Service Bulletin No. 452B

MODEL J4500	TYPE Field Change Program	SECTION/GROUP 12-Suspension	DATE
SUBJECT FRONT SWAY BAR			
CONDITIONS

THIS BULLETIN SUPERCEDES SERVICE BULLETIN 452 IN ITS ENTIRETY.

Figure 2. Sway bar installation.

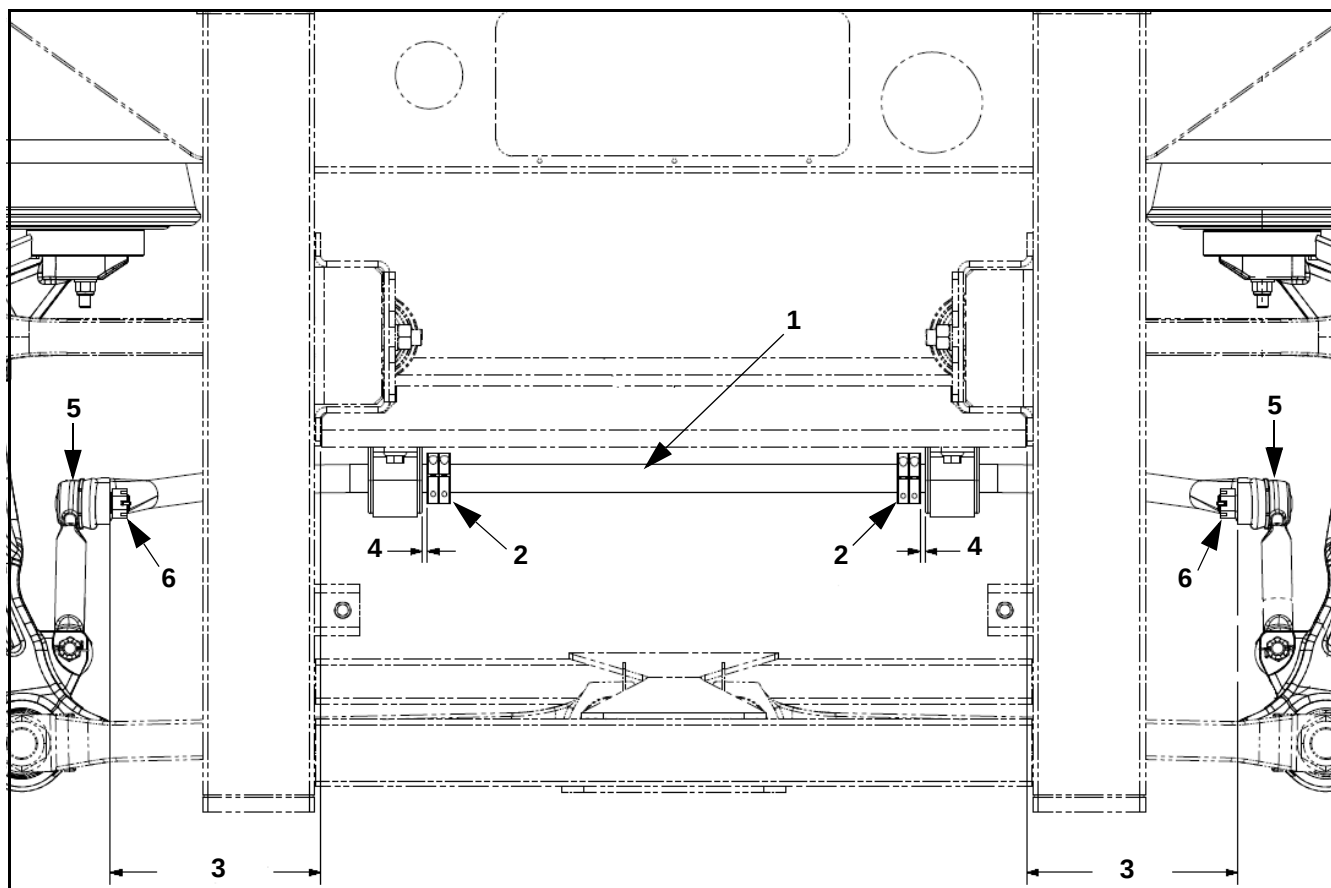
Motor Coach Industries ("MCI") has become aware that a defect which relates to motor vehicle safety exists on the front sway bar used on certain front axles. The potential exists whereas the front sway bar may crack at the bushing / clamp locations.

Fatigue failure of the sway bar under certain conditions.

3. Remove and discard the existing front axle sway bar.
4. Install the new sway bar and service kit components as shown in Figures 2 and 3.

Item	Figure 2 Description
1	Sway bar
2	Collar. Torque collar allen bolts to 155-175 in-lbs.
3	Distance of 9.37 inches
4	Distance of 0.25 inch
5	Existing sway bars links. Ensure sway bars links are vertical and spaced equally from uprights.
6	Existing castle nut
